# COMBINATION EDITION

# Wizards Workshop

* **********************************	**
TEKTRONIX INTERNAL USE ONLY	
Published by Service Admin Support 56-037 Ext. 8939 Merlo Issu	st 8, 1980 e 0-16
TABLE OF CONTENTS	
PERSONNEL CHANGES	. 1-2
GENERAL	
STOLEN INSTRUMENTS (INTERNATIONAL)	. 3
ADMINISTRATIVE SUPPORT	
REPORT DISTRIBUTION	. 4
LABORATORY INSTRUMENT DIVISION	
5000 SERIES	
5440/R, 5441/R READOUT MALFUNCTION	. 5
5440/R, 5441/R TRANSISTOR AVAILABILITY	. 5
067-0883-99/067-0919-99	. 6-7
7B87, INSURE STARTING OF CLOCK OSCILLATOR	. 8-9
COMMUNICATIONS DIVISION	
MEDICAL	
CRT_SOCKET_KIT_P/N 040-0876-01	. 10
400 RECORDER TENSION GATE	. 10

### 7B87, INSURE STARTING OF CLOCK OSCILLATOR

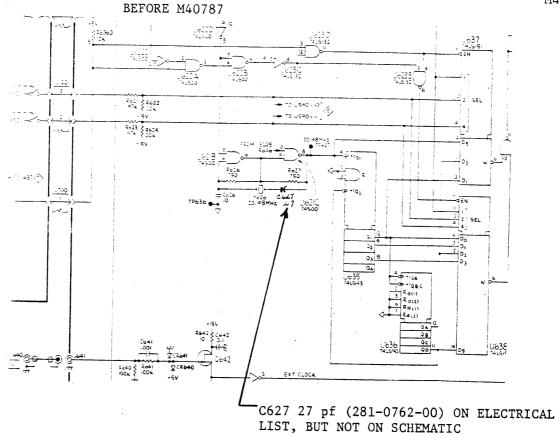
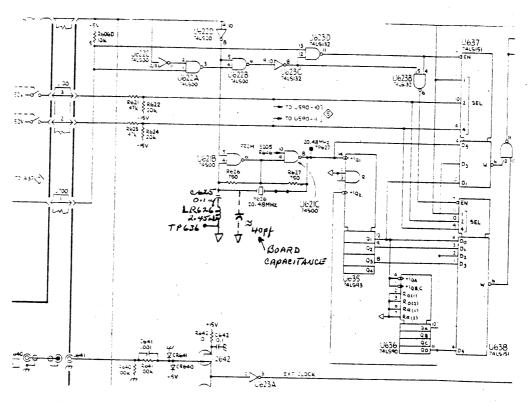
At serial #B010121 a mod was installed to insure that the clock generator would start at any sweep speed when the unit was powered up. The problem would only show up when the time per division was set to very fast sweep speeds. The mod consisted of changing C627 from 27pf, P/N 281-0762-00, to a 0 ohm resistor, or terminal link connector, P/N 131-0566-00. Also change C626 from a 10pf, P/N 281-0811-00, to LR626, a 2.45µh, P/N 108-0797-00. LR626 must be installed on the back side of the boards. Cut the run between LR626 and Y626 and add C625, .01µf cap P/N 281-0775-00, in series with LR626. Connect the other end of the capacitor to R626, 7.5 ohm resistor, on the end connected to pin 4 of U621B, as shown on the following schematics.

#### 211, 212, 213, 214, 221 POWER CORD

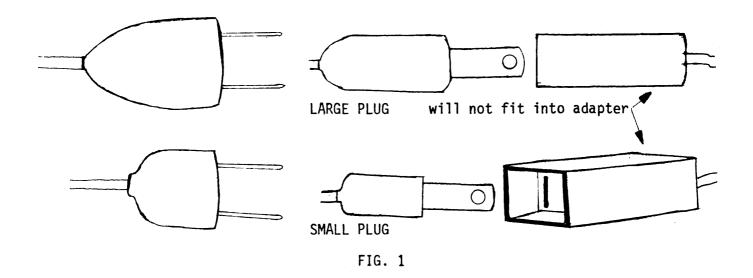
Due to a change of vendors, a larger, two-terminal plug power cord for the 200 Series scopes was put into the stock system (see Fig. 1). This large plug will fit into the storage compartment for the AC plug on the 212 and 214 instruments, and will not fit the 211, 213, and 221 instruments.

However, some 212 and 214 instruments are shipped with a power plug adapter, P/N 161-0077-01, and the large plug will not fit into this adapter because the female receptical is recessed. (The adapter has one end to accept the smaller plug and one end which has just a power cord, so the user may adapt any type power plug he desires.)

All the large plug-type power cords have been removed from stock, and all service center stocks should be purged. Reorder the cords as necessary. Both styles of power cords have the same part number.

DIAGRAM A

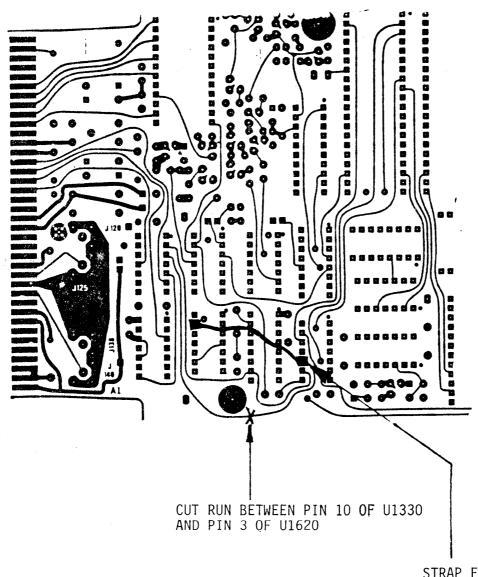
SOLUTION: On the backside of the A30 Programming Logic Board (670-4916-XX) cut the run between Pin 10 of U1330 and Pin 3 of U1620 as shown in Diagram 'A'. Strap Pin 10 of U1330 to Pin 13 of U1530 as shown in Diagram A.

STRAP FROM PIN 10 OF U1330 TO PIN 13 OF U1530

DIAGRAM B
PARTIAL OF SCHEMATIC DIAGRAM 6

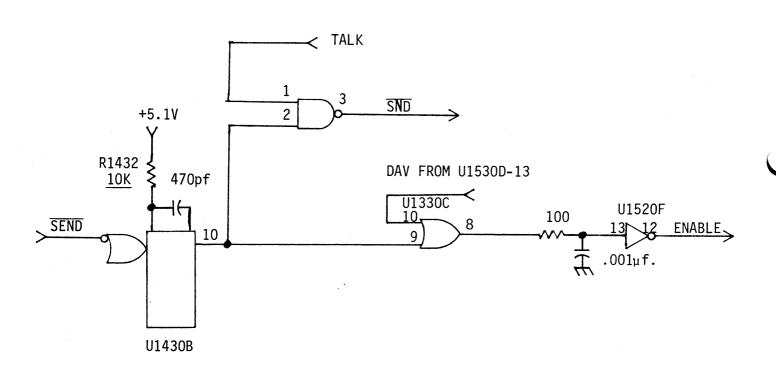
Replace R1432 (7.5 K $\Omega$ ) with a 10 K $\Omega$  resistor Part Number 315-0103-00. This changes 670-4916-02 to a 670-4916-03.

The schematic representation is shown in Diagram B.

#### PARTIAL OF SCHEMATIC DIAGRAM 7

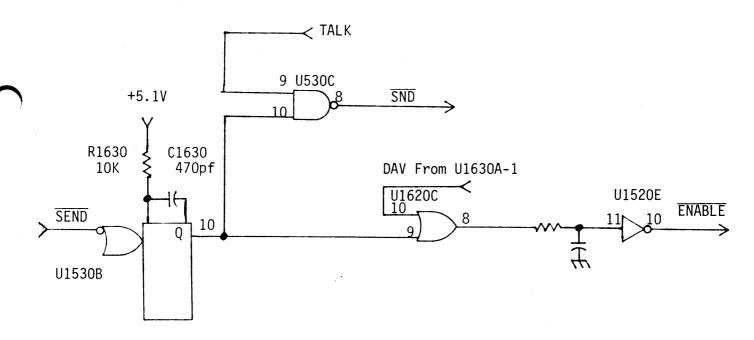
SOLUTION: Lift Pin 10 of U1620 of the A50 Programmer Board (670-5039-00). Then strap lifted Pin 10 of U1620 to Pin 1 of U1630. Remove C1630 and R1630. Replace C1630 with a 470 pf capacitor Part Number 283-0032-00 and replace R1630 with a 10 K $\Omega$  resistor Part Number 315-0103-00.

This mod changes the  $670-5039-\underline{00}$  to a  $670-5039-\underline{01}$ .

The schematic representation is shown in the following diagram.
